ROLLING MEADOWS CHANNEL & FLOODPLAIN MODIFICATION

60% DESIGN PLANS
MARCH 2023

MATRIX PROJECT No. 21.1129.009

THE LANDHUIS COMPANY			
ROLLING HILLS CHANNEL AND FLOODPLAIN MODIFICATIONS 60% DESIGN PLANS			
HORIZONTAL CONTROL PLAN - UPPER REACH			
DESIGNED BY:	TKM	SCALE:	DATE ISSUED:
DRAWN BY:	EAL	HORIZ 1" = 600'	MARCH 2023
CHECKED BY:	AJS	VERT. N/A	SHEET
			08 OF 47
			DRAWING No. HZ02

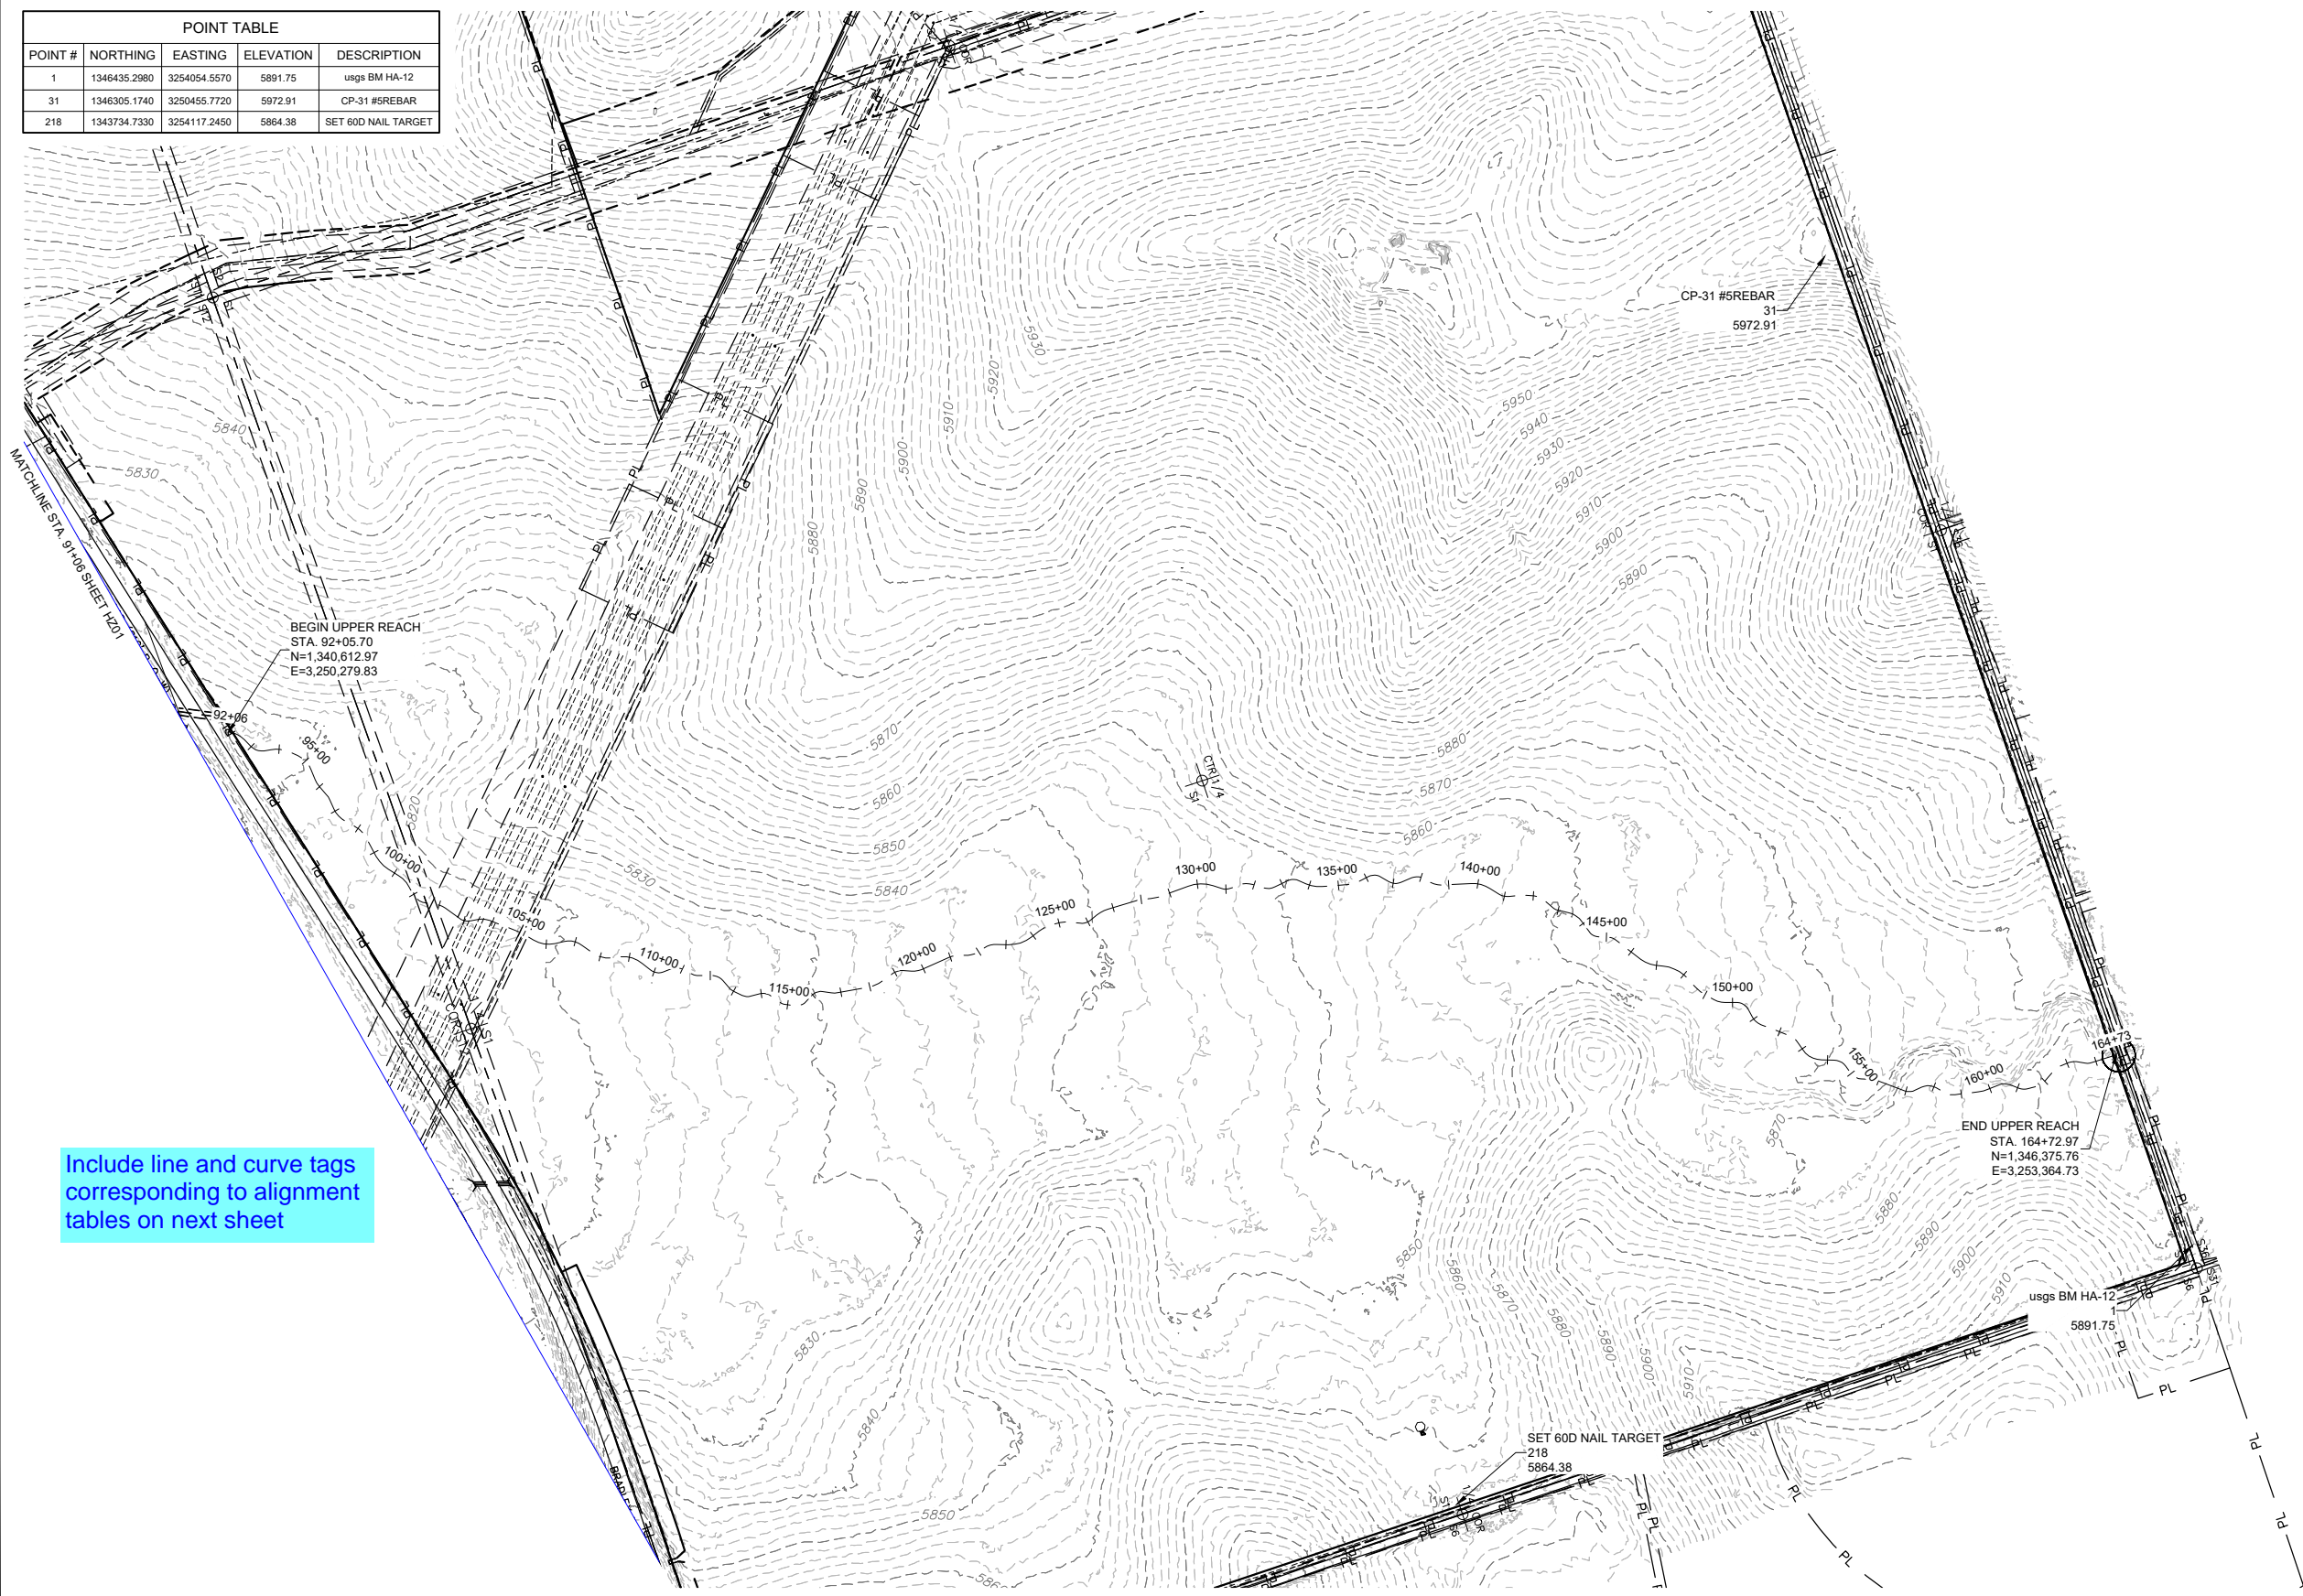
Include line and curve tags corresponding to alignment tables on next sheet

PLAN AND PROFILE
STA. 5+00 - 20+00

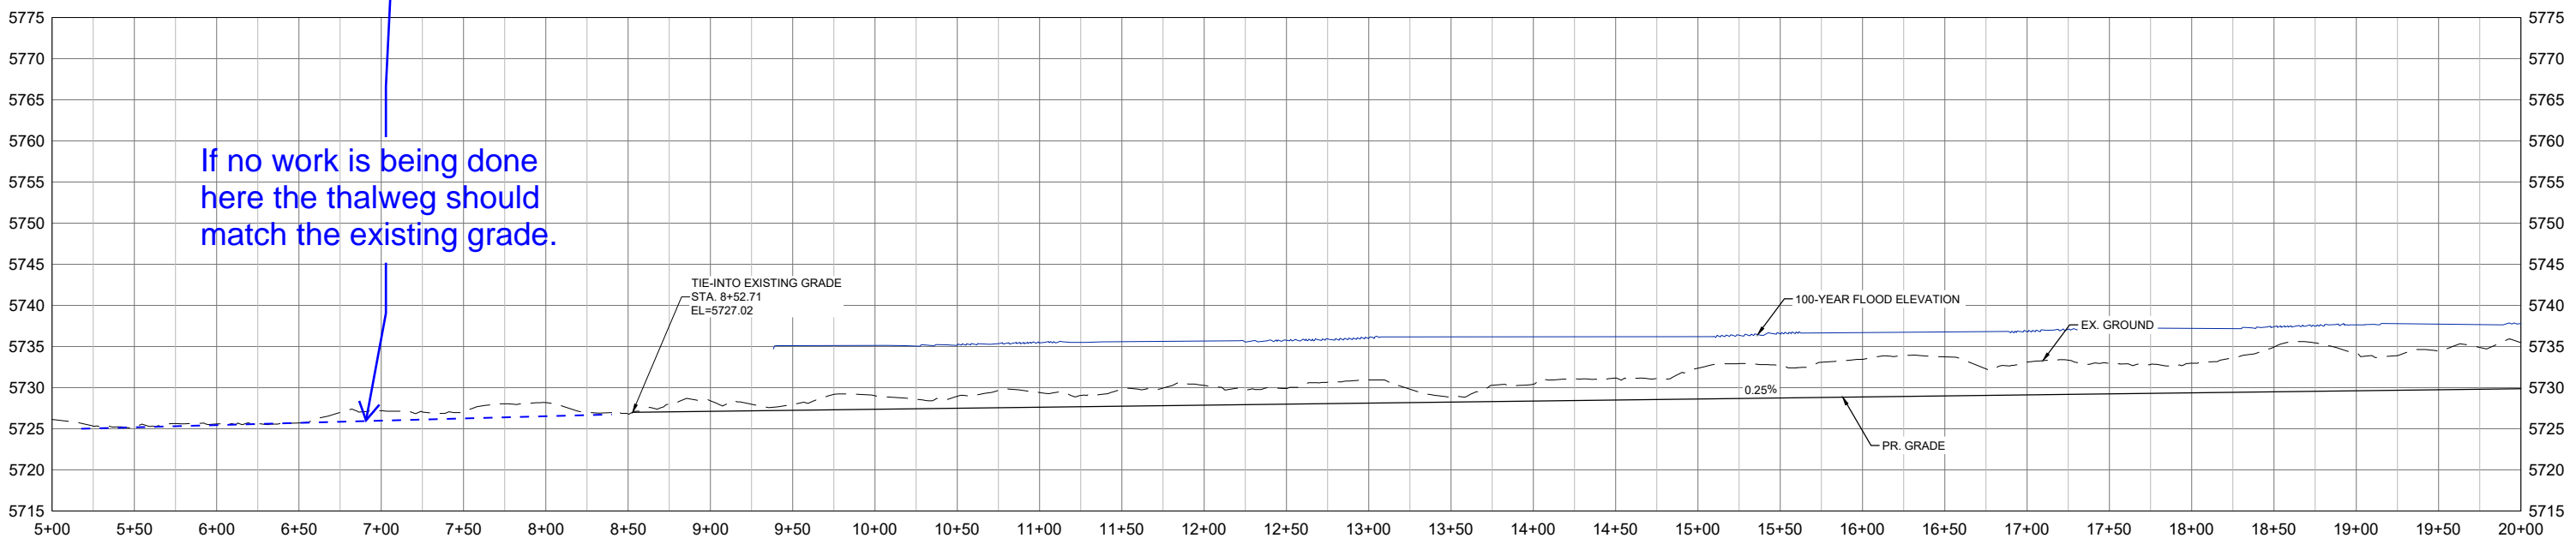
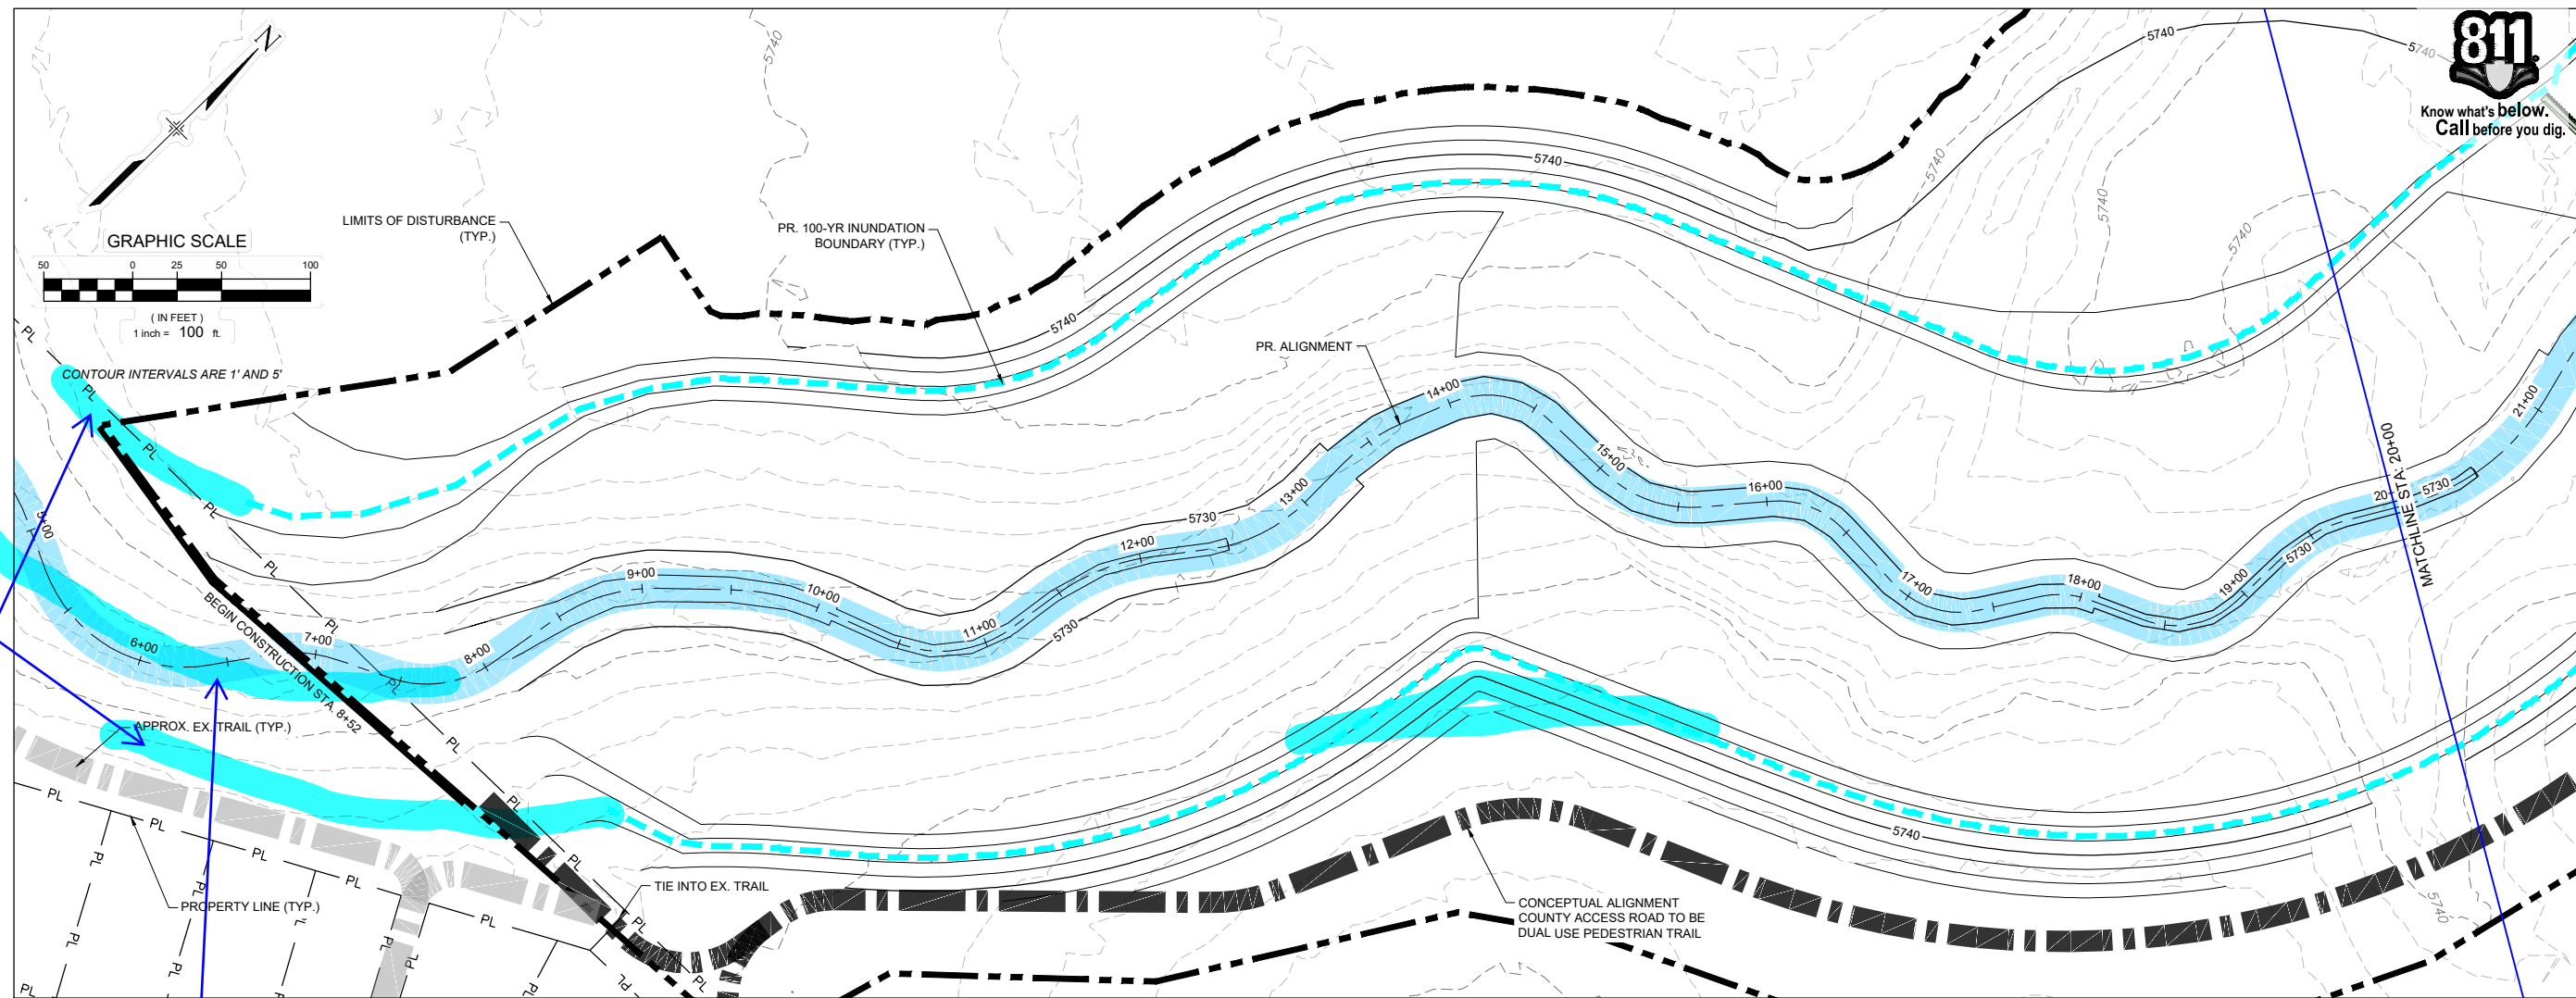
Please show 100-yr boundary to verify downstream cross-section.

If no work is being done here the thalweg should match the existing grade.

PLAN AND PROFILE
STA. 77+00 - 89+00

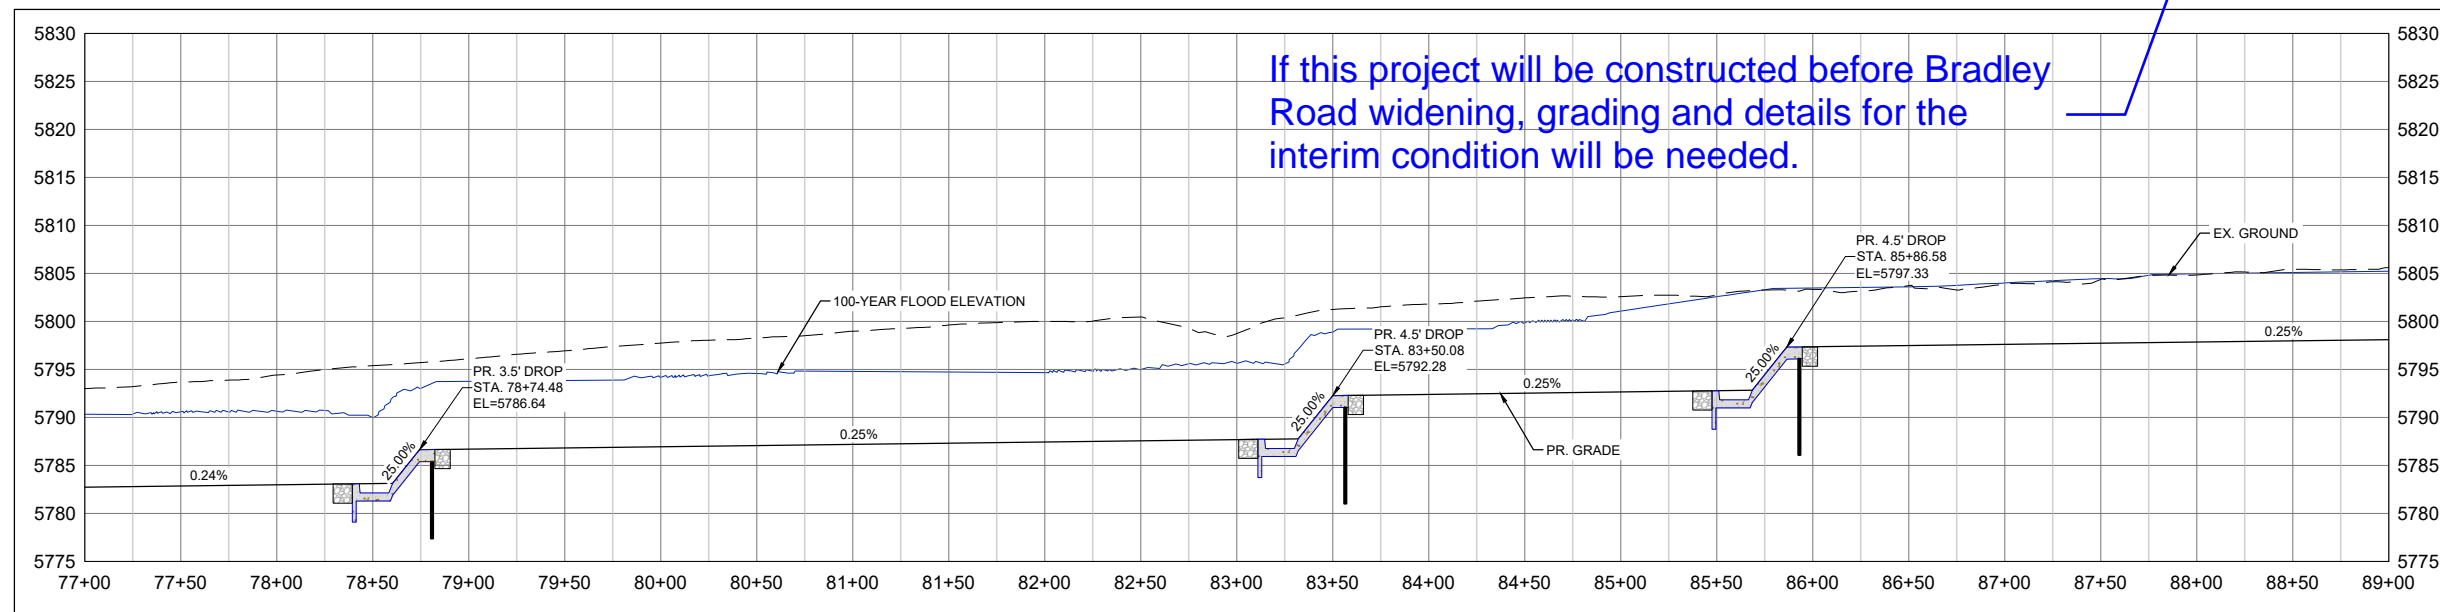
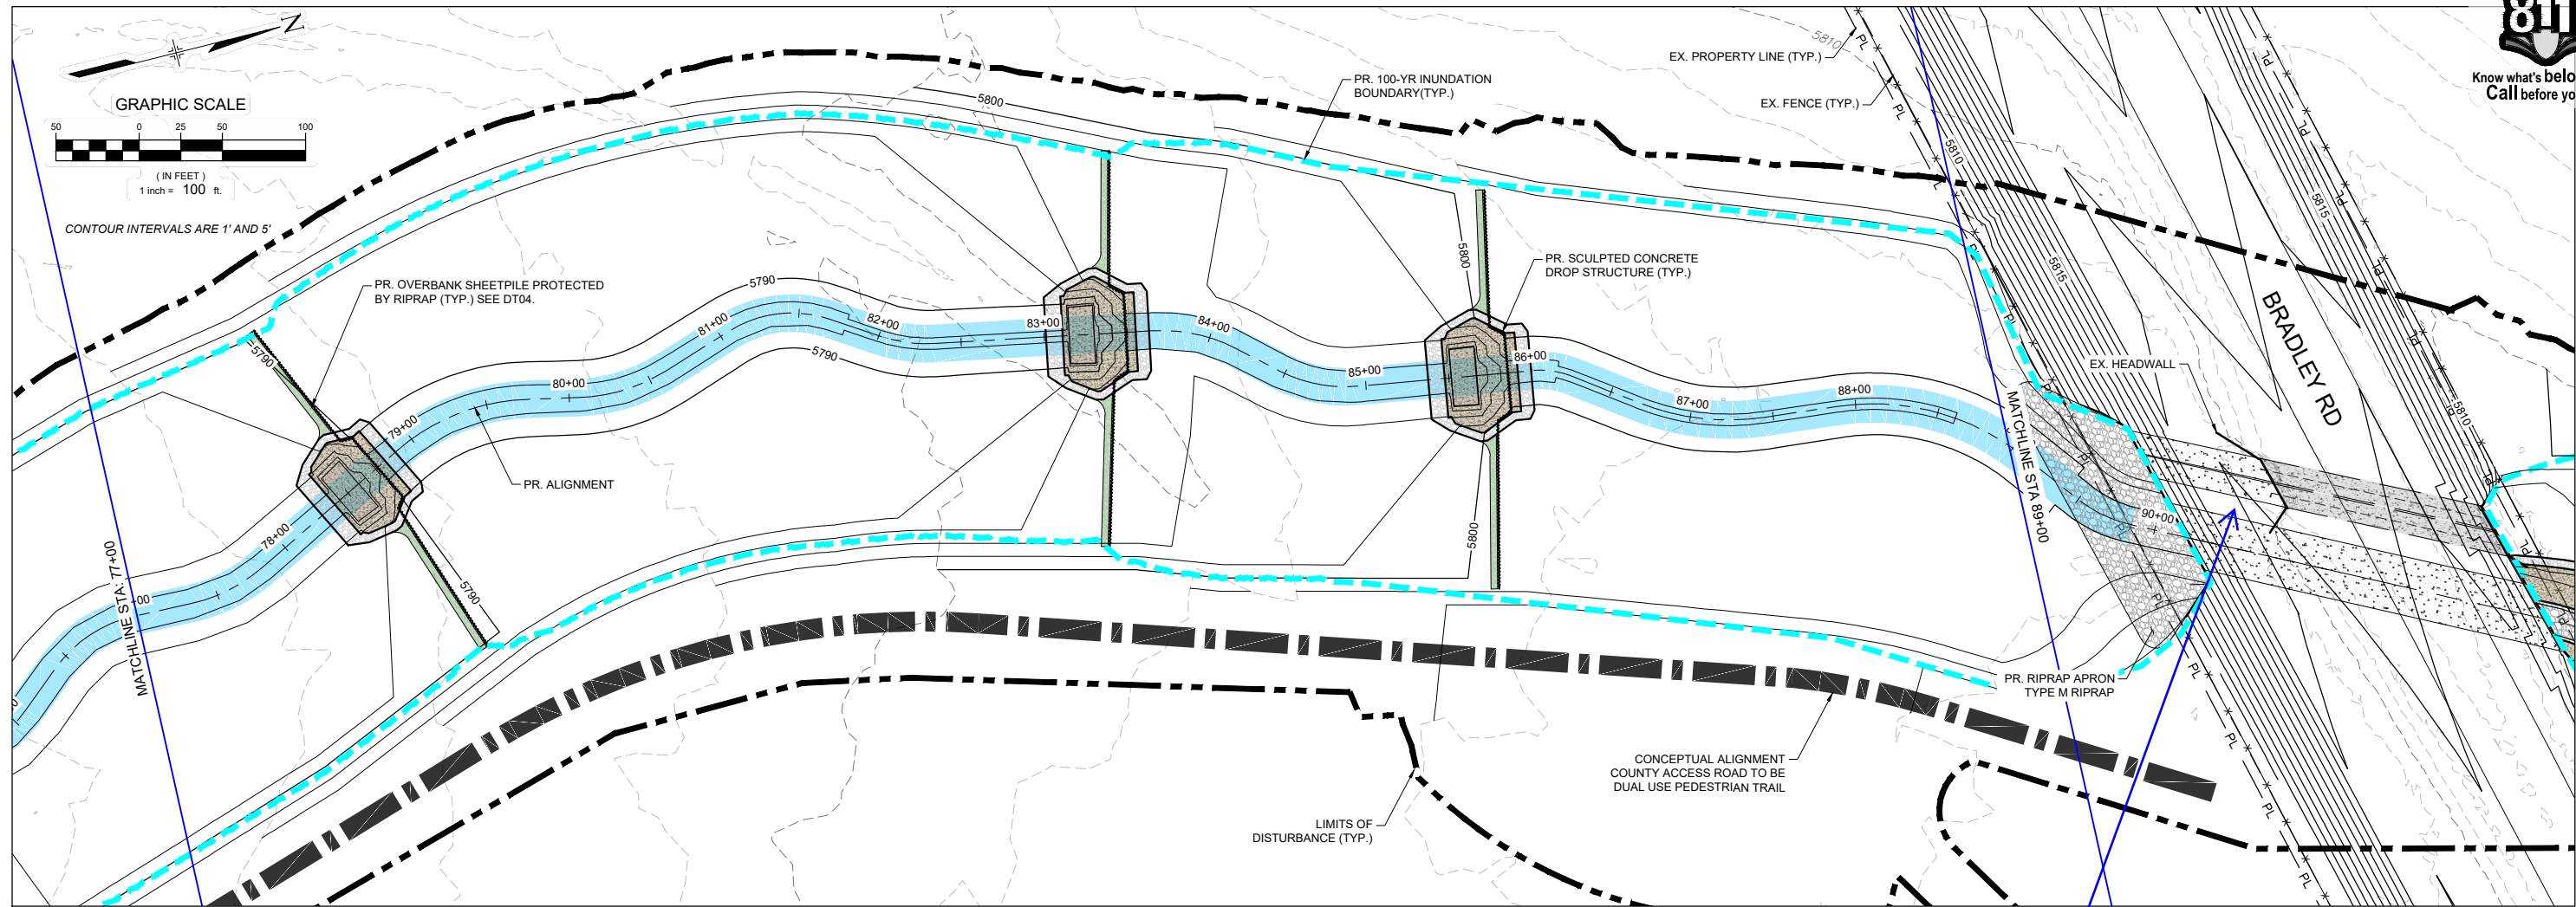
If this project will be constructed before Bradley Road widening, grading and details for the interim condition will be needed.
